ITS4880R

Octal Smart Power High-Side-Switch for Industrial Applications

Errata Sheet

Rev.1.0, 2014-10-10

Figure 1 Pin configuration ITS4880R, PG-DSO-36

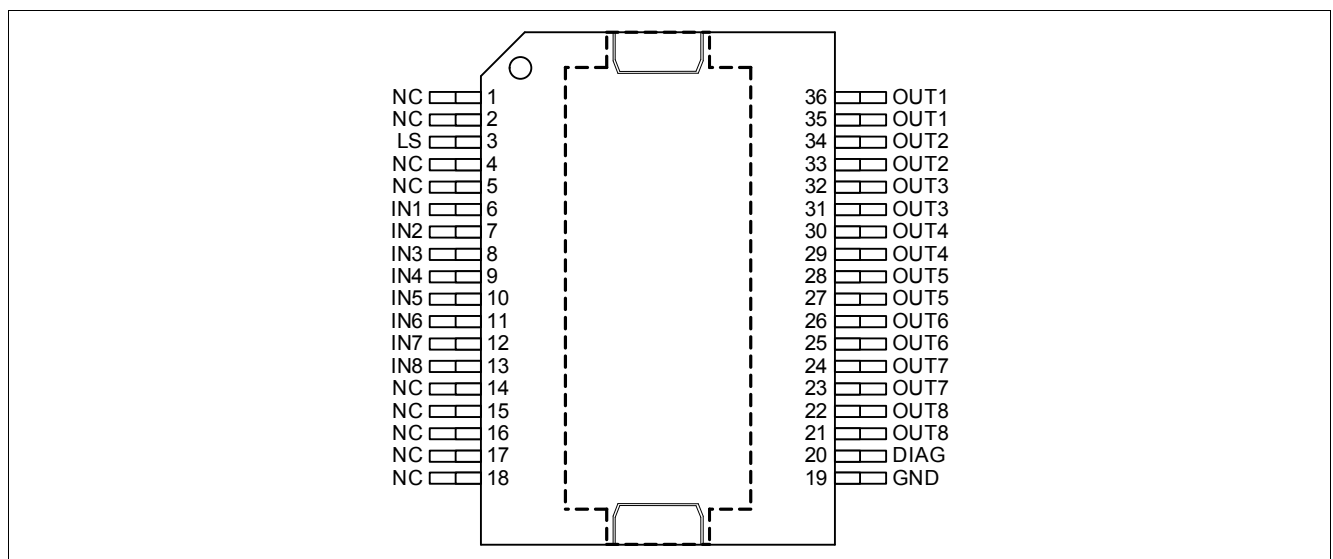
The functionality of the LS pin (Pin 3) for the ITS4880R as described in Data Sheet Rev. 1.1 on page 9 is valid for static conditions. Determined by the high impedance of the LS-pin and the capacitance of the LS-protection to V_{BB} , the functionality can be affected by high slew rates on V_{BB} . In order to avoid this, the LS pin should not be left open and should be connected either to GND or to supply voltage. If the LS pin is connected to the supply voltage V_{BB} the input threshold is set to 50% of V_{BB} . Connecting the LS pin to GND sets the input threshold to CMOS levels.

Change in Data Sheet: Changes will be made as described below under the section 'Functional Description LS-Pin' of the ITS4880R Datasheet Rev.1.1.

The following statement in the datasheet: 'If the LS-pin is not connected the input threshold voltages are automatically at CMOS levels' is valid for static conditions. Depending on the slew rate at V_{BB} , the internal network with R_{LS-GND} which is typically 800k Ω causes a voltage overshoot on LS, which might lead consequentially (due to

parasitics) to a permanent deviation of the described LS-pin behavior (voltage level between CMOS and $V_{BB}/2$ levels).
